MMD Fan Hub Bolt Torque

Section Function Group 263

Model Years	Models
2023	MD6, MD7

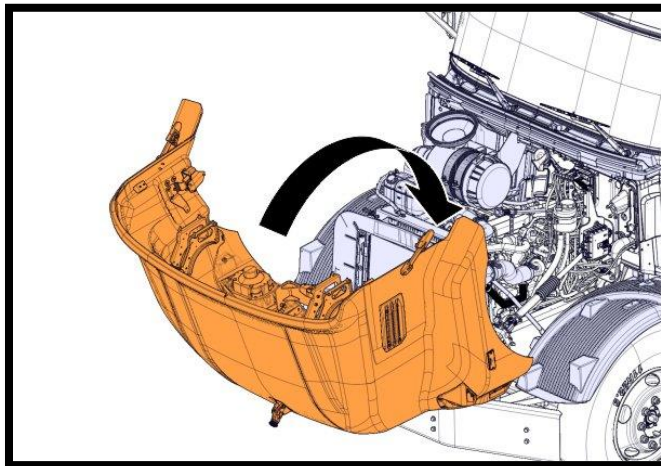
Mack trucks has determined that certain model year 2023 Mack Medium Duty (“MMD”) vehicles, may have been assembled with an under torqued condition on the fan hub retaining hardware. To correct this issue and uphold Mack’s stringent quality standards, a retorque of the hardware is required.

7. Using a torque wrench, retorque the 4 fan hub mounting bolts to **$24\pm4\text{Nm}$ ($10\pm3\text{lbf}\cdot\text{ft}$)**

Tightening torque	
Fan hub mounting hardware	24±4Nm (10±3lbf·ft)
